**WILLIAM
PATERSON
UNIVERSITY**

ADDENDUM NO 1

TO: All Prospective Bidders
DATE: 8/17/17
PROJECT: New Residence Hall (WP-16-01-99-B)

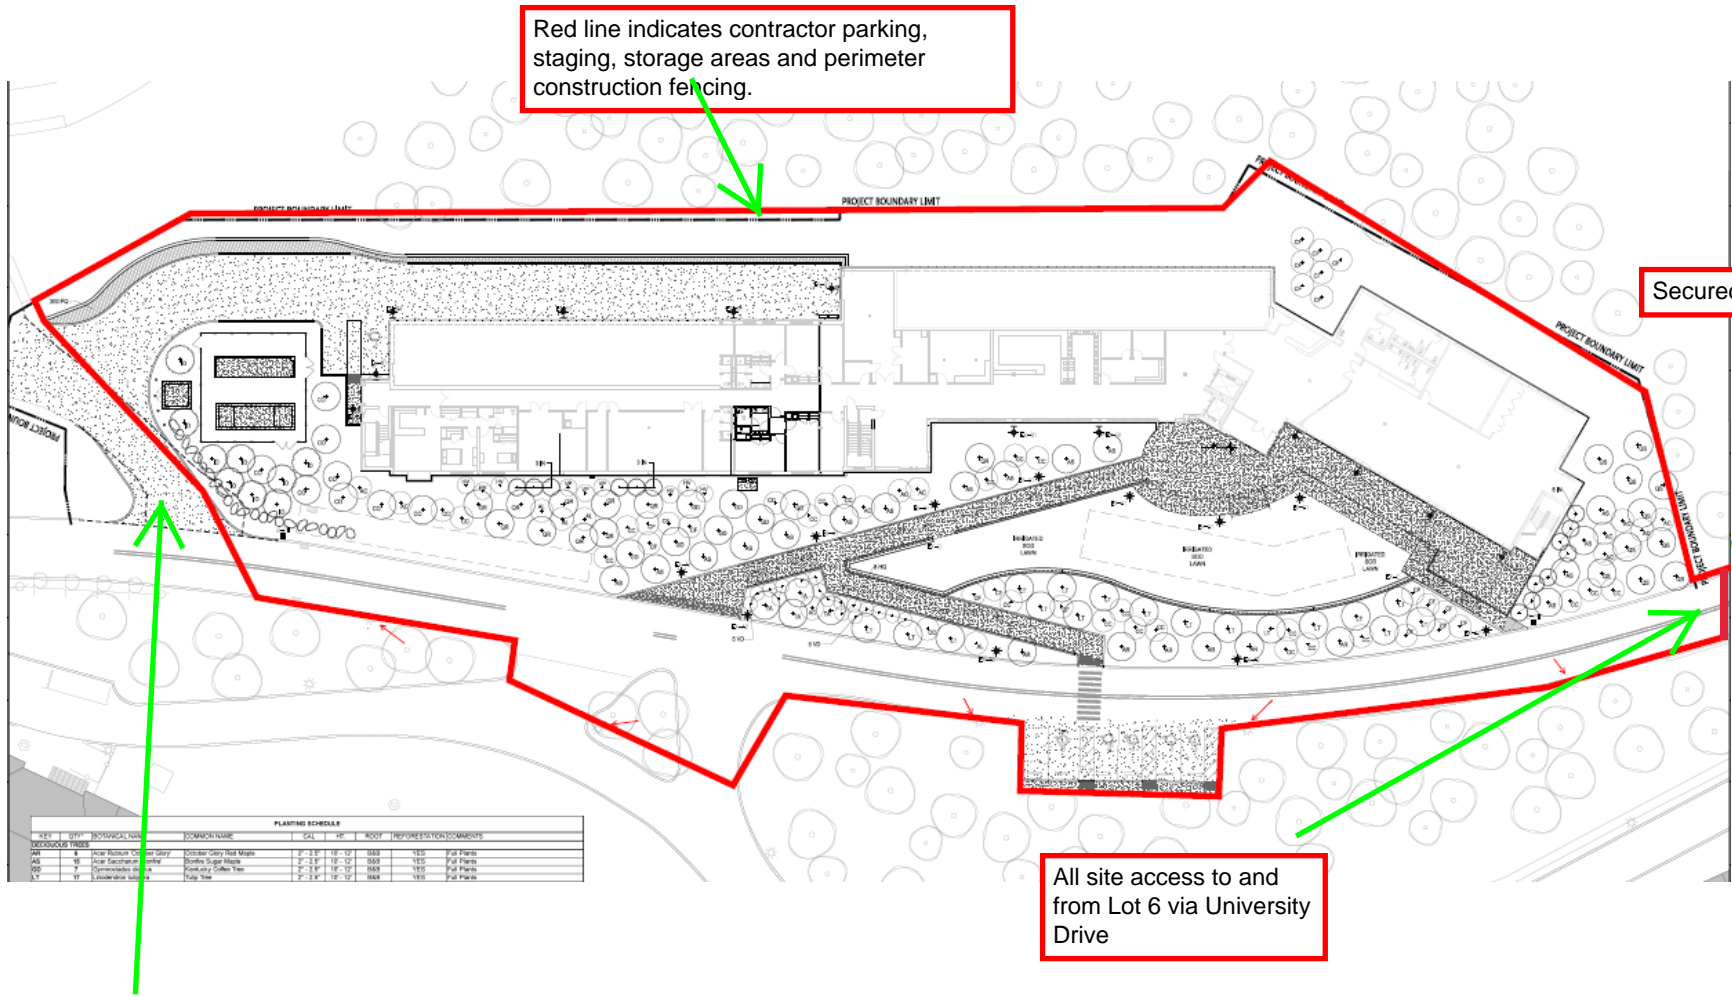
Q5: Drawing P-101: Need piping sizes for sanitary and vent systems, missing in many areas.

A5: All sanitary, vent and/or waste pipe sizes are indicated on Drawing P-006 (Sanitary Riser Diagram).

1 ELECTRICAL SITE PLAN
SCALE: 1" = 20'-0"

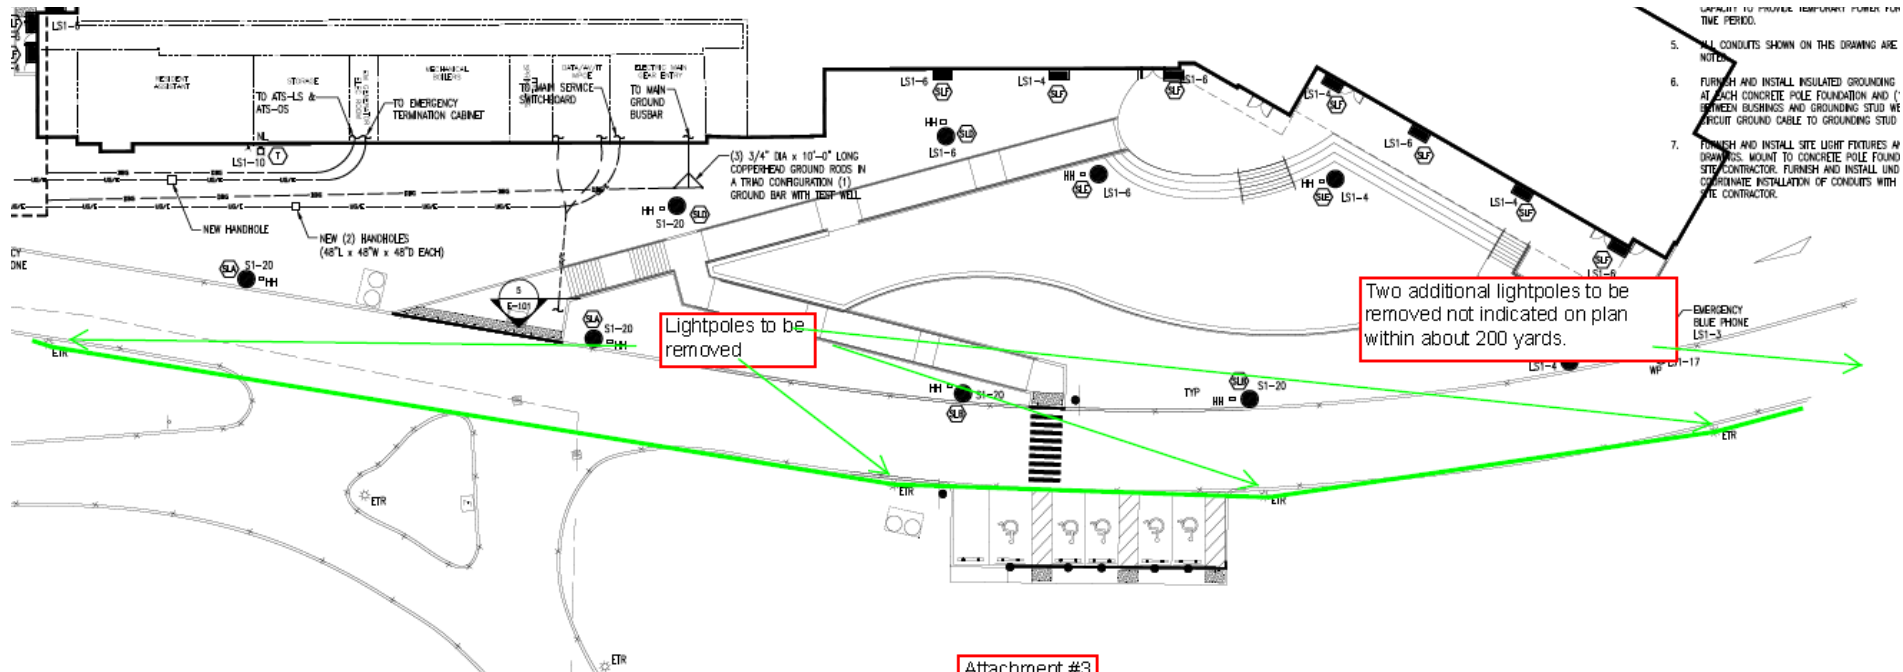
10. Drawing E-101, Detail 1 shows several light poles indicated as existing to remain (see Attachment #3). The underground electrical feed between the light poles has been indicated by an added line. This line serves exterior lighting for pedestrian and vehicle safety outside of the project site. As a result this underground feed must be protected, maintained, repaired and replaced by the contractor for the duration of the project. Once the new exterior lights for the new residence hall are operational and accepted by the University, the feed will be disconnected by the University and the contractor will be required to remove and dispose of 6 existing light poles and bases that are currently scheduled to remain in the drawings.
